**DOCUMENT 00 9113  
ADDENDUM NO. 2  
9/18/24**

**SPECIFICATION NO. 24-11658-C**

**CIVIC CENTER PARK UPPER PLAZA IMPROVEMENTS PROJECT  
2135 MARTIN LUTHER KING JR WAY BERKELEY, CA 94705**

**IRRIGATION PLAN**

**L5.00**

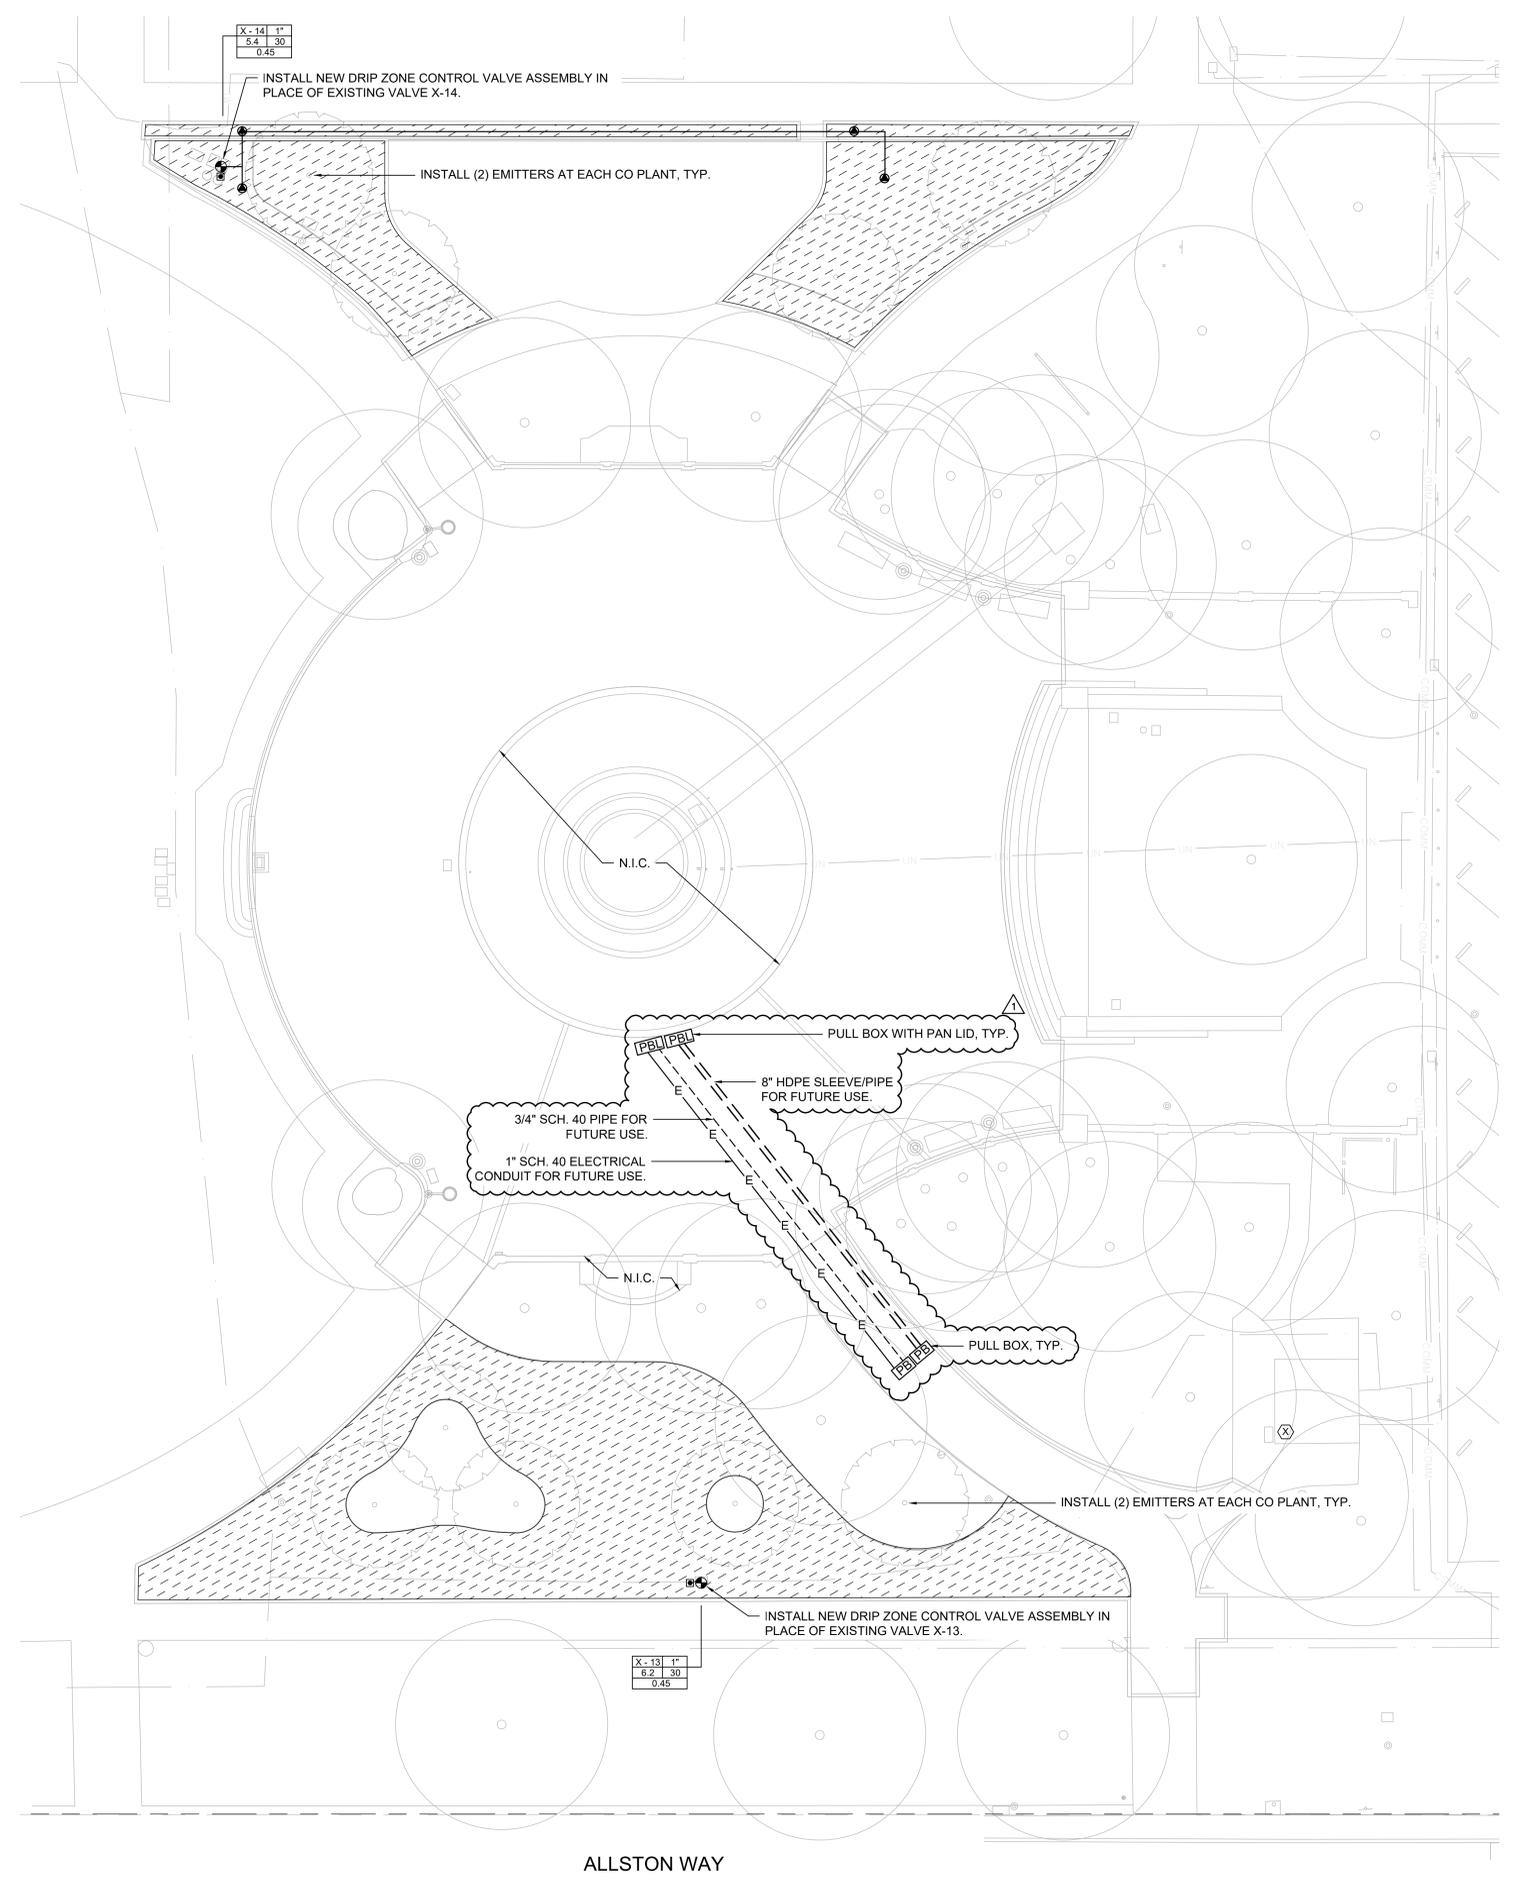
1. What is the size and material of the sanitary sewer sleeve for future use shown in sheet L5.00?

Addendum #1 Response: An 8" HDPE sleeve shall be used.

Update: This change from Addendum No. 1, and additional pull boxes have been added to the plan. Please see the revised Irrigation Plan attached herewith.
